**Meeting of the Central Valley Flood Protection Board
August 24, 2012**

Staff Report – Encroachment Permit

Dixon Regional Watershed – Joint Powers Authority

Dixon Main Drain and V-Drain Project, Solano County

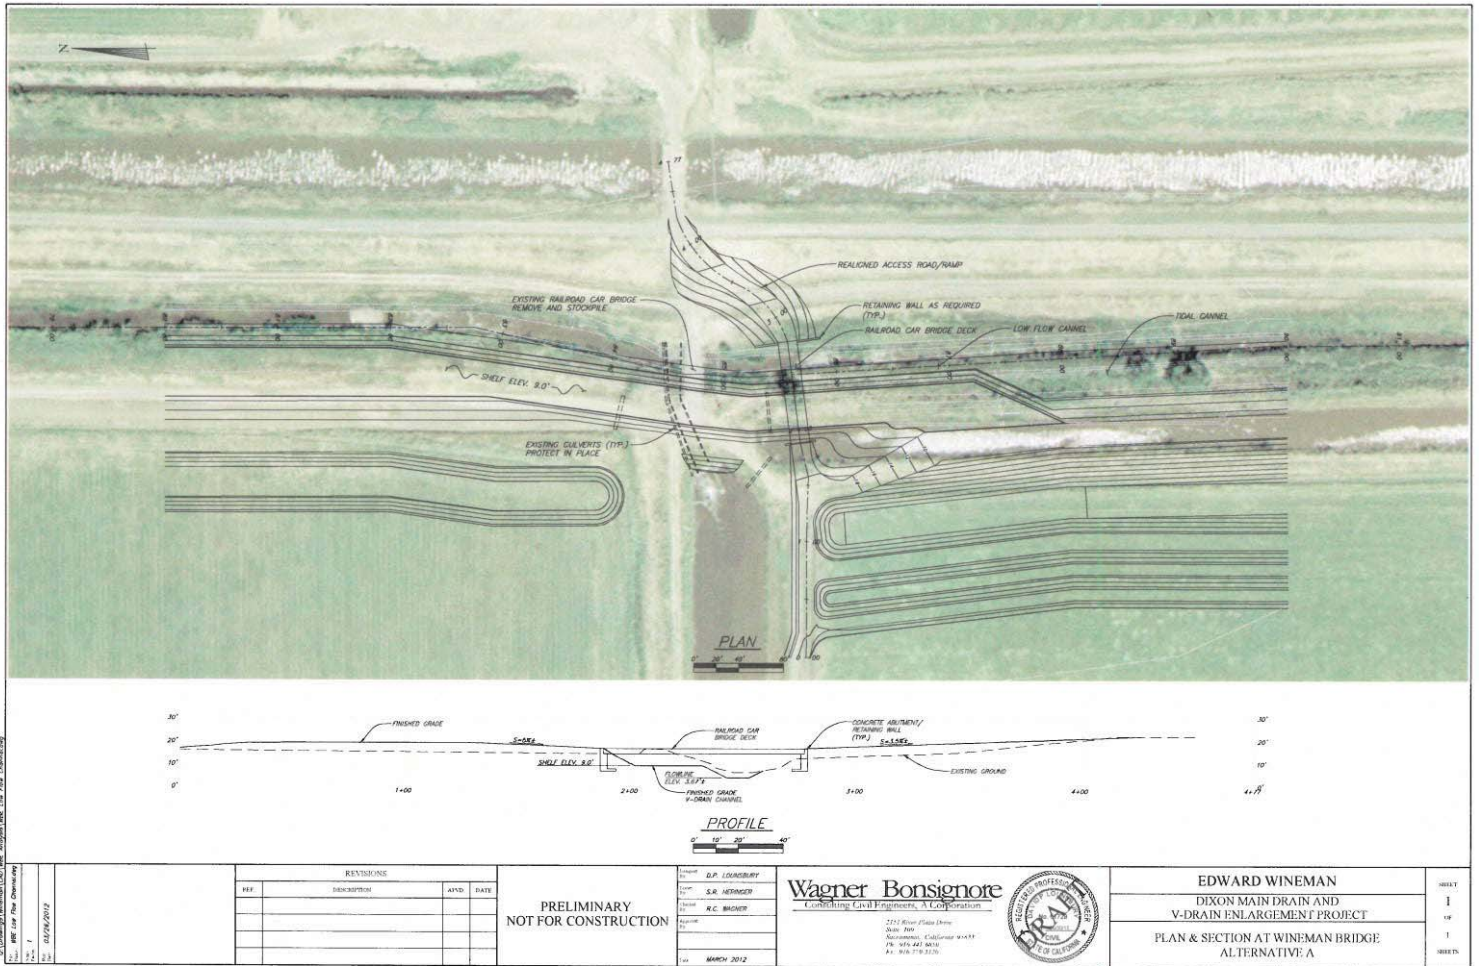
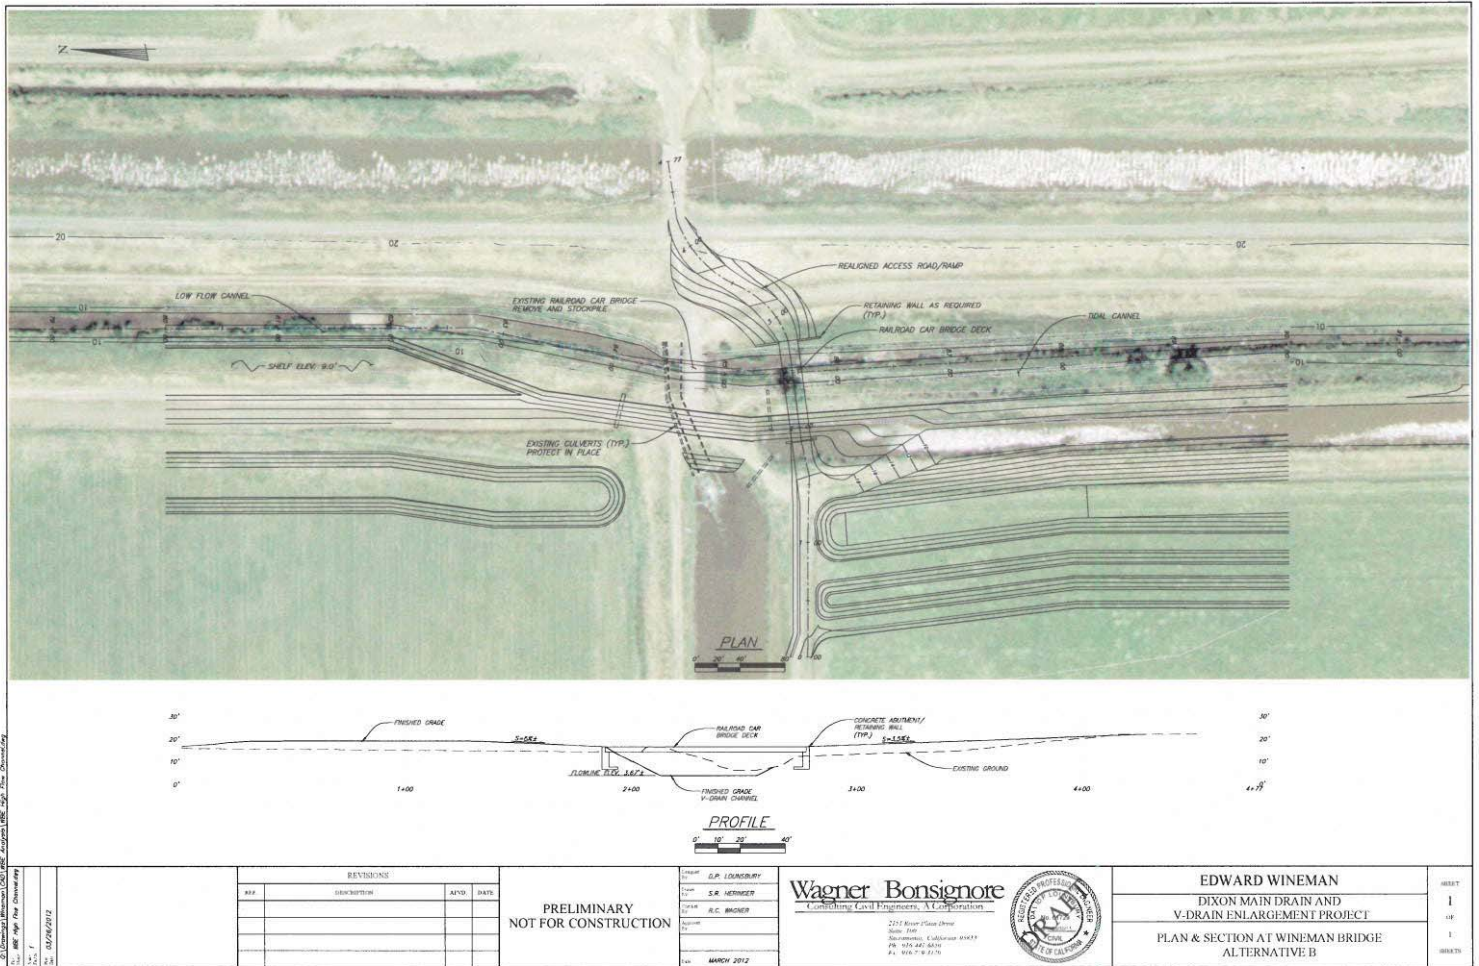
Alternative B consists of the same bridge as described in Alternative A, with a difference in the channel bottom grading. A plan and profile of the approach road and bridge section is attached. The Alternative B bridge channel section extends the tidal channel section upstream through the bridge section where it then transitions to the low flow channel design section. The preliminary bridge design is conceptual; however locating the bridge across the V-Drain with a deck bottom elevation of 14.0 feet creates a flow area of about 660 square-feet which is about 380 square-feet greater than the existing/unimproved bridge section design. The modified channel grading section increases the flow area and theoretical flow capacity over the Alternative A concept; however maintenance of vegetation would be more difficult and a lack of maintenance would constrict the flow capacity of the channel significantly thereby potentially negating the benefit of the increase flow area.

The cost for bridge structure would be the same as shown for Alternative A as the difference is in the V-Drain channel grading beneath the bridge structure.

The elevation of the bridge deck may be raised or lowered and placement of rip rap may still be required depending on the results of hydraulic analyses. We request a hydrologic analysis on the V-Drain channel utilizing the proposed Alternative B bridge and channel section be performed for further evaluation.
